# CITY PLANNING COMMISSION

APPLICATION: A. Negative Declaration  
B. Special Permit to establish a 24-hour convenience store within 500 feet of residential uses (Sec. 2-C-11(a)).

LOCATION: 7595 Franklin Boulevard

PROPOSAL: The applicant is requesting the necessary entitlement to establish a 24-hour convenience store within 500 feet of residentially zoned property.

**SITE PLAN**  
**7595 FRANKLIN BOULEVARD**  
SACRAMENTO CALIFORNIA

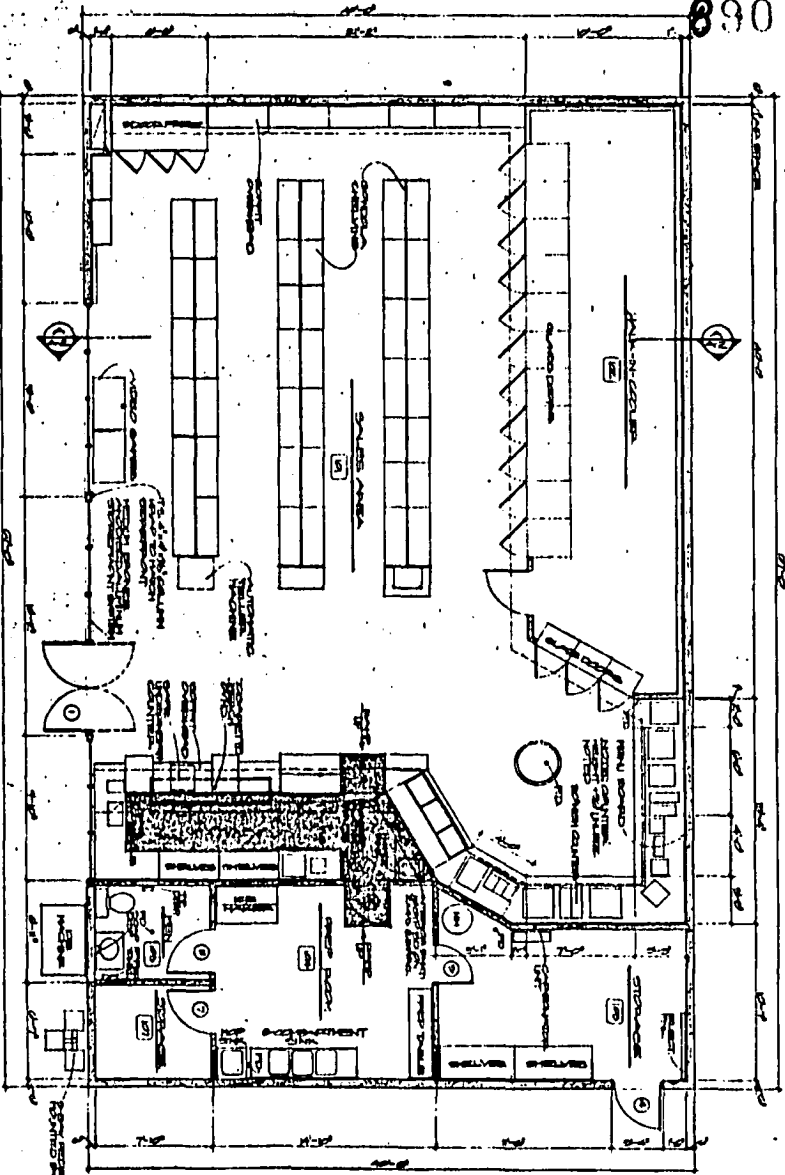
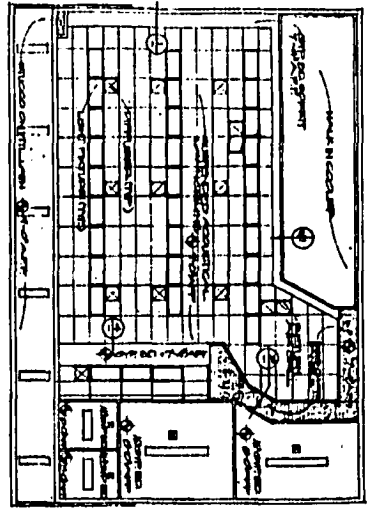
- D. Circulation: The subject site will require regrading and new surfacing to accommodate the proposed development. The City Traffic Engineer requests that the plans be revised to locate one driveway on Brookfield Drive located approximately 65 feet from the eastern property line. This will entail closing the existing driveway to the satisfaction of the City Traffic Engineer. The required parking must meet the 50% shading requirement. The applicant should be aware that the 50% shading compliance could require elimination of parking spaces and redesign of the landscape plan. In addition, the applicant must bring the existing planters up to current City standard which includes irrigation. Landscaping plans should include the area north of the proposed structure which will not be needed as driveway due to the Traffic Engineer's recommendations. Eleven parking spaces are required for the Circle K operation.

- E. Staff is including Exhibit A as criteria for construction of a trash enclosure. This should be located at the northwest corner of the building.
- F. The applicant has no specific user for the 1,800 square foot 'future satellite' designated on the site plan.

- G. The applicant is responsible for constructing a six-foot solid masonry wall along the south property line. Signage is subject to Building Permit approval.

- 1. The existing driveways on Brookfield Drive shall be abandoned and removed to the satisfaction of the City Traffic Engineer.
- 2. A new driveway shall be located approximately 65 feet from the eastern property line to the satisfaction of the City Traffic Engineer.

- 3. A trash enclosure shall be located at the northwest corner of the building. The enclosure shall be constructed according to Exhibit A.
- 4. The remaining area north of the structure shall be landscaped and irrigated according to plans approved by the Planning Director prior to issuance of building permits.

- 5. Existing planters shall be brought up to City Code, including irrigation.
- 6. Improvement plans shall indicate compliance with the 50% parking lot shading requirements.

- 7. The applicant shall construct a six-foot solid decorative masonry wall along the south property line. Design of the wall shall be reviewed and approved by the Planning Director.
